**GOVERNMENT OF THE DISTRICT OF COLUMBIA
DEPARTMENT OF TRANSPORTATION**

MEMORANDUM

SUBJECT: ZC Case No. 16-23 – The Lady Bird

Figure 1 – Site Plan (Source: CTR, Gorove/Slade, Figure 8, 11/22/17)

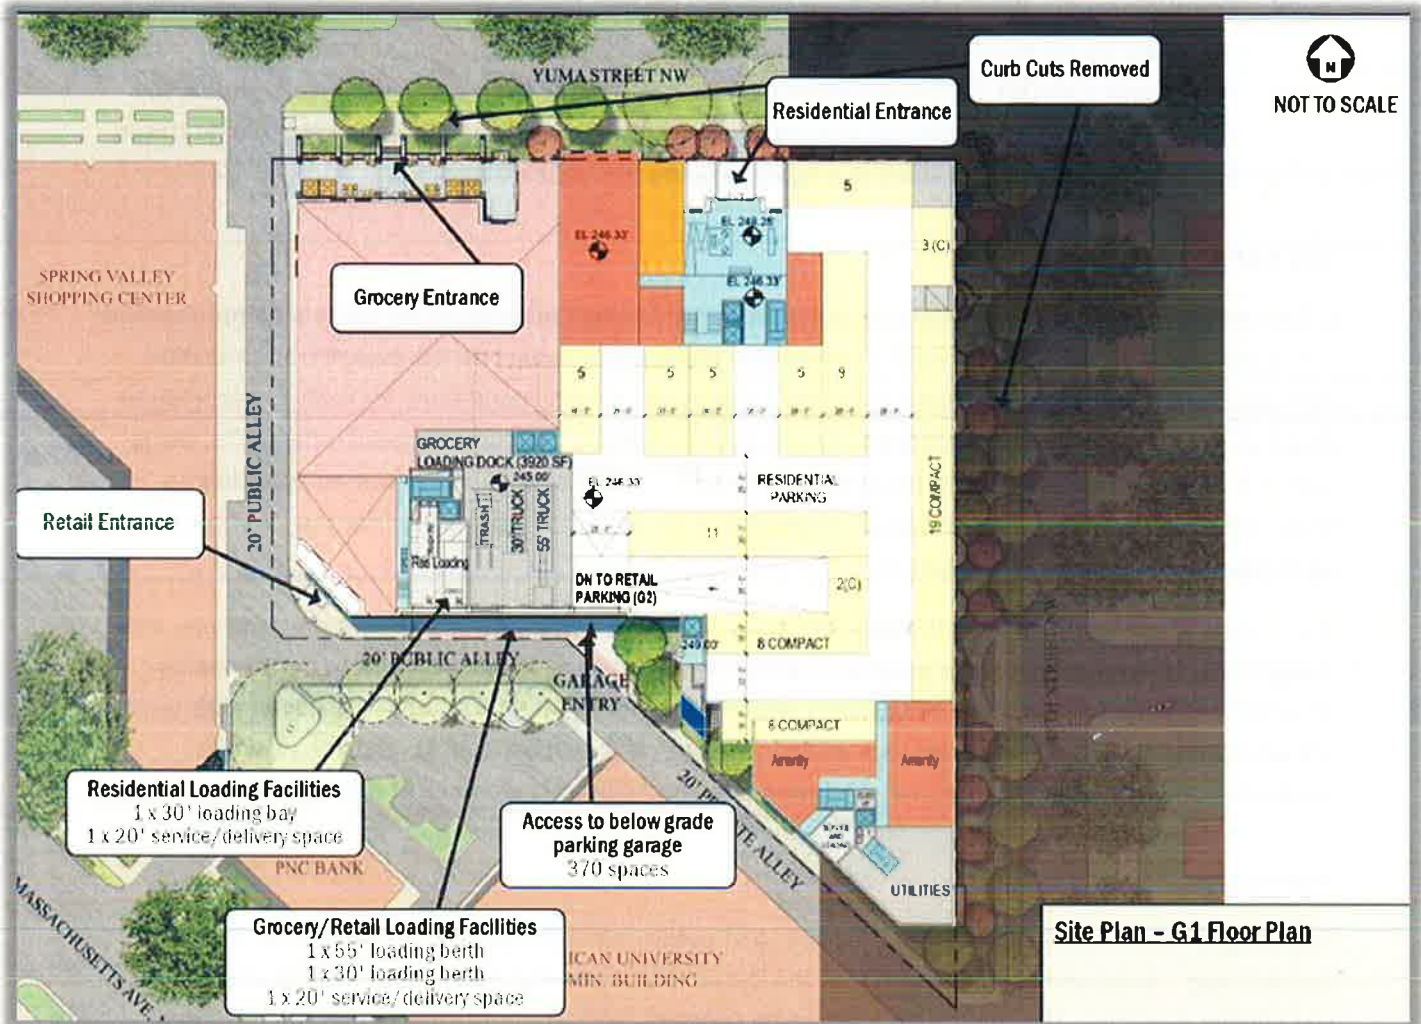
DDOT is in concurrence with the proposed loading scheme as shown in Figure 1, so long as the loading management plan discussed above is in effect and the Applicant adds the following additional items:

- The loading management plan shall also apply to the Spring Valley Shopping Center site;
- All trash bins and dumpsters currently located along Yuma Street NW will be relocated to the alley and placed in the proposed enclosures; and
- Trucks traveling to the Spring Valley Shopping Center will be directed not to pick-up or drop-off on Yuma Street NW and will be directed to use the rear alley network.

While the preliminary public space plans, shown above in Figure 1, are generally consistent with DDOT standards, there are several considerations that need to be incorporated and items to be reviewed in greater detail during the public space permitting process:

- The existing Yuma Street NW alley curb cut and apron should be shifted to the east to be consistent with the new alignment of the alley;
- DDOT concurs that the existing curb cuts on Yuma Street and 48th Street NW should be closed and replaced with green space and street trees;

- The sidewalk clear zone width on Yuma Street NW is proposed to be 8-feet near the grocery store entrance and then narrowed to 6-feet along the residential portion of the project. The edge of sidewalk should maintain a straight line along the northern edge of the sidewalk;

- An occupancy permit will be required for the outdoor café seating currently shown in public space near the Yuma Street NW grocery store entrance;
- Building projections on Yuma Street NW should not project more than 4-feet into public space;

- The concrete strips running north-south in the middle of the green space near the grocery store entrance on Yuma Street NW should be removed;
- DDOT finds the design of the proposed trash enclosures along the public alley appropriate and will require a public space occupancy permit;

- All dumpsters currently located in public space along Yuma Street west of the alley and east of Exxon, which is within this Design Review application's plan area, should be moved to the new enclosures in the public alley; and

- There are several segments of pavement in public space along Yuma Street west of the alley and east of Exxon. These areas should be restored to green space with leadwalks connecting from the sidewalk to building entrances.

Figure 2 – Proposed Alley Improvements (Source: CTR, Gorove/Slade, Figure 10, 11/22/17)

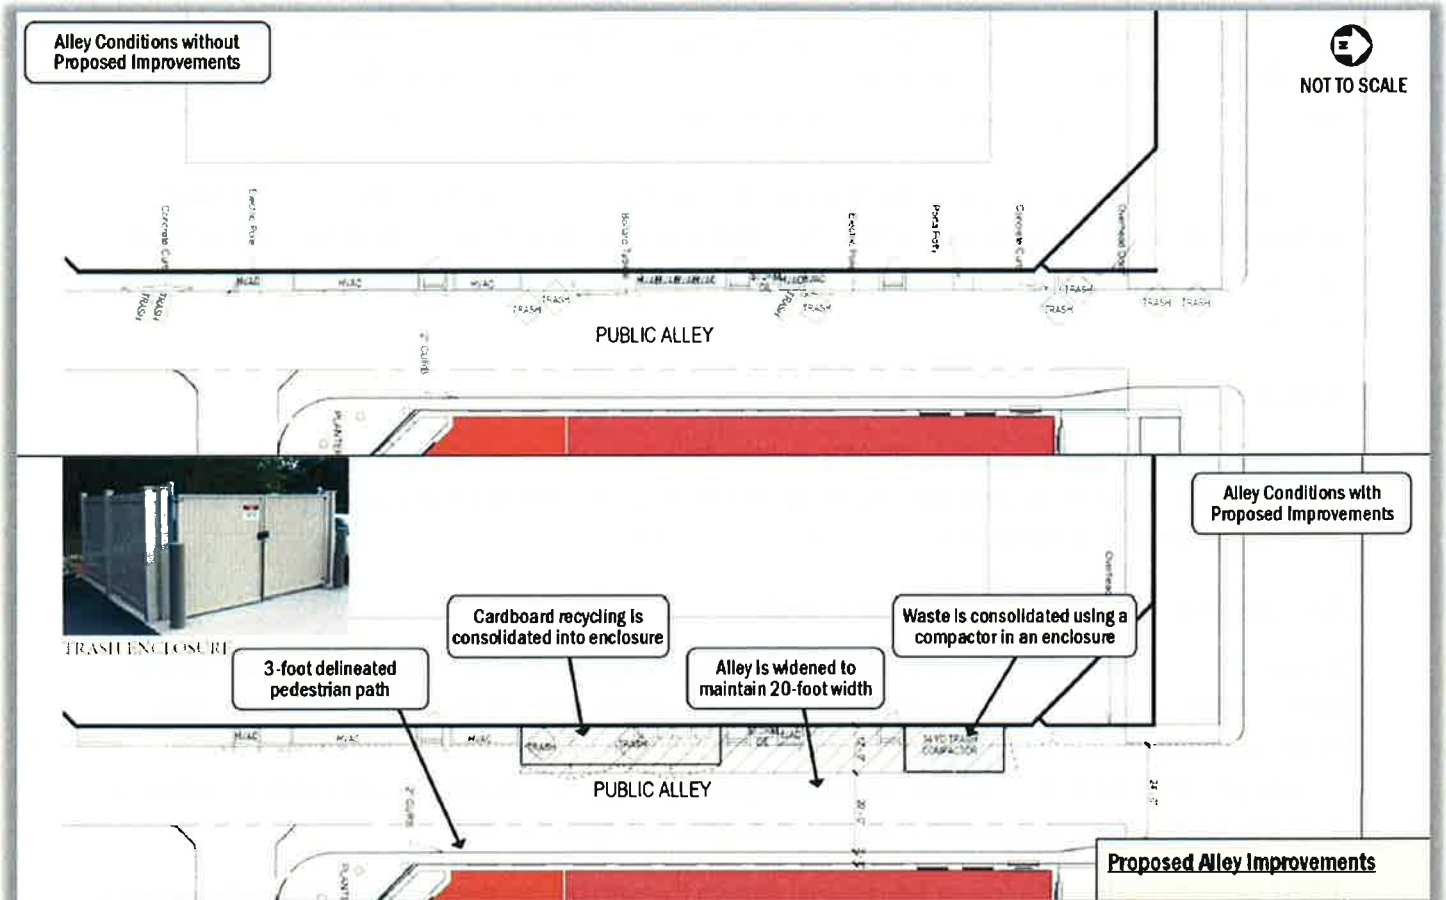
As shown below in Figure 2, the Applicant has proposed to enclose the trash containers from the Spring Valley Shopping Center that are currently partially sitting in the public alley. The containers currently occupy approximately 5 feet of private space west of the alley and 7 feet of public space within the alley. In order to keep the full 20-foot width of the alley, the Applicant plans to widen the alley by 7 feet on private property to the east. DDOT concurs with the Applicant’s proposal so long as the widened alley segment is within a public access easement, a public space occupancy permit is obtained for trash enclosures, and the alley curb cut is shifted to the east to be consistent with the new alley alignment.

Figure 5 – Existing Pedestrian Infrastructure (Source: CTR, Gorove/Slade, Figure 33, 11/22/17)

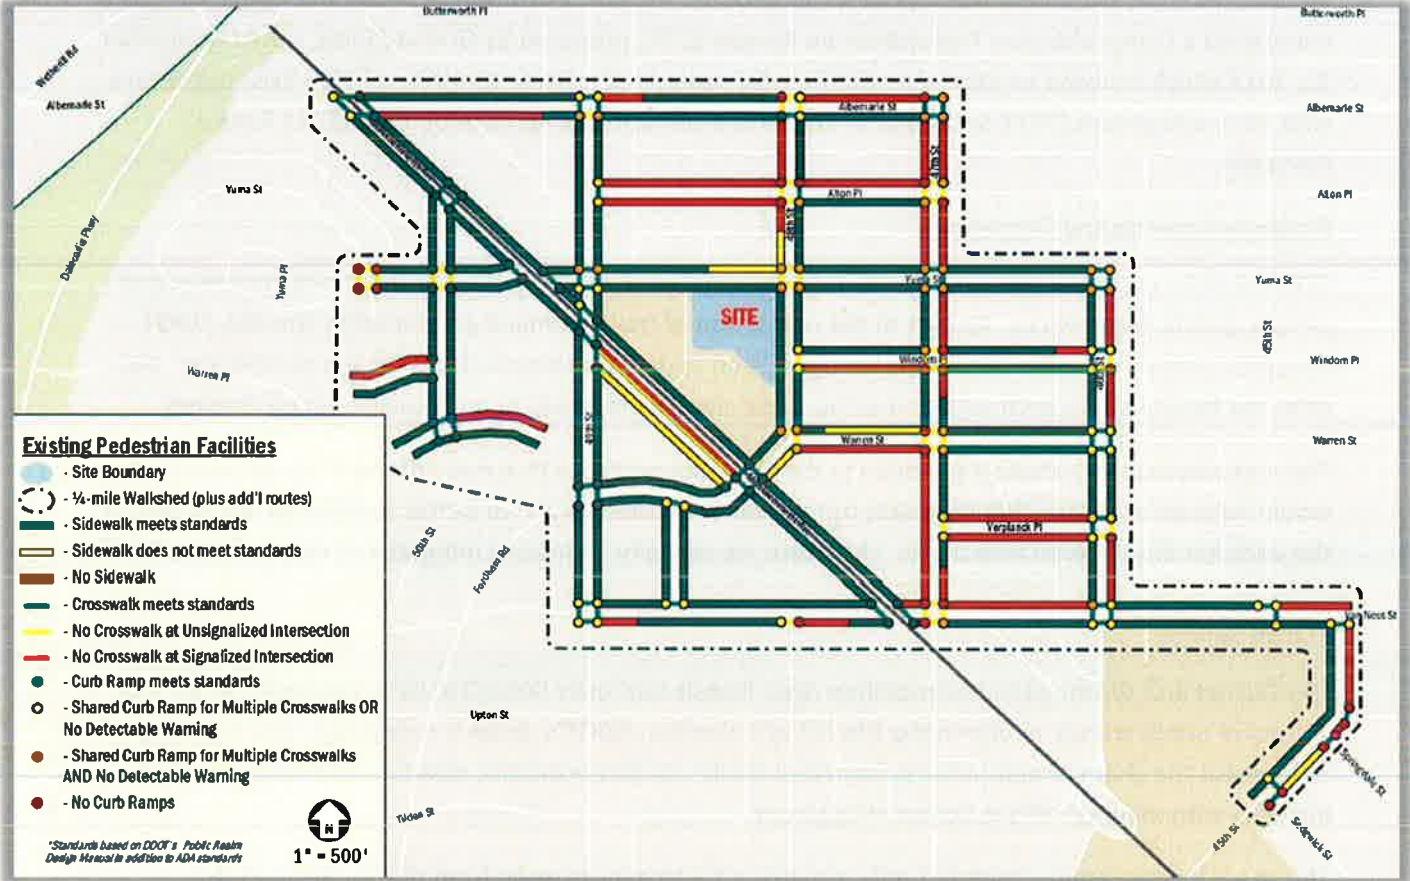
The Applicant’s inventory of existing pedestrian infrastructure, as shown in Figure 5 below, demonstrates that most sidewalks in the immediate vicinity of the site are currently constructed with appropriate widths. However, there are numerous curb ramps that do not meet DDOT standards and should be upgraded. While there are a few missing or substandard segments of sidewalk and curb ramps in the broader area, the existing pedestrian network along major pathways to schools, attractions, and the Metrorail station is generally adequate.

DDOT expects that the Applicant will reconstruct the public space along the frontage on both Yuma Street (from the Exxon driveway east to 48th Street NW) and 48th Street (from Yuma Street south to the Warren Street NW) and upgrade any pedestrian facilities to current DDOT standards. Additionally, several submitted drawings show sidewalks constructed along the alley connection from Massachusetts Avenue NW. DDOT expects at a minimum a sidewalk will be provided along the western side of the alley until it reaches the trash enclosures at the rear of the Spring Valley Shopping Center.

As discussed previously in the Vehicle Parking section, to offset the impacts of being over-parked, DDOT recommends the Applicant fund and construct several pedestrian network improvements in the immediate vicinity of the site to encourage walking and discourage driving. Specifically, the Applicant should upgrade sub-standard curb ramps, stripe missing crosswalks, and install curb extensions on all

corners of the following intersections. These curb extensions will make the stop signs more visible to drivers, shorten the crossing distance for pedestrians, and slow turning vehicles.

- 49th Street and Yuma Street NW
- 48th Street and Yuma Street NW
- 48th Street and Windom Place NW
- 48th Street and Warren Street NW
